Model: SR7300

Subject: Broken Knob

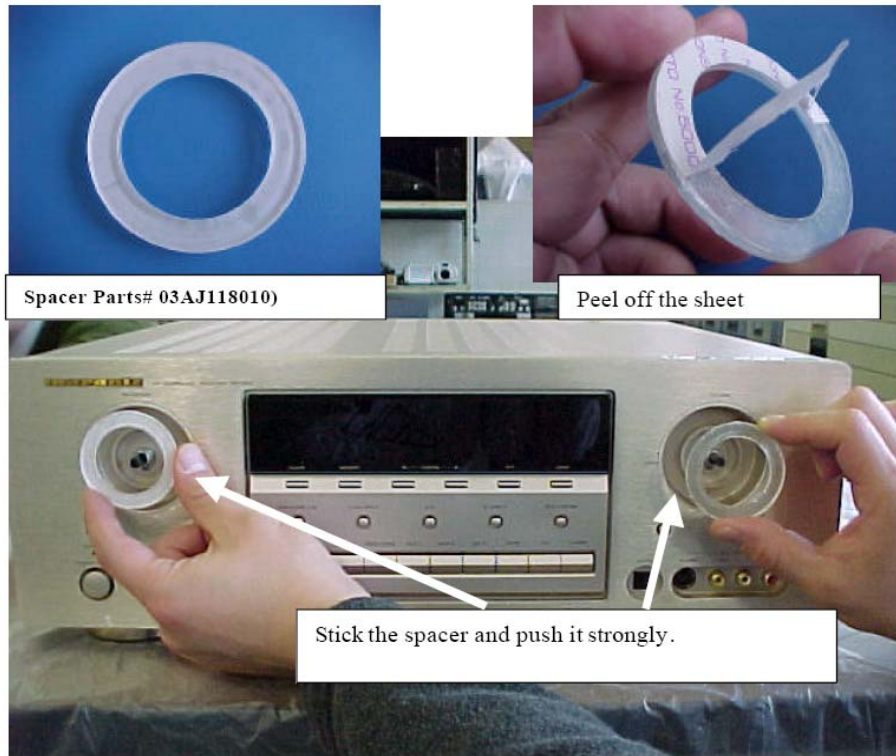
Symptom: Broken Volume or Selector knob by transportation. The clearance between the front panel and knob is a little large and this can stress to the volume or selector shaft.

Solution: Add the spacer (see parts) to the front panel as follows:

Ref#	Description	Part Number
NA	SPACER	03AJ118010
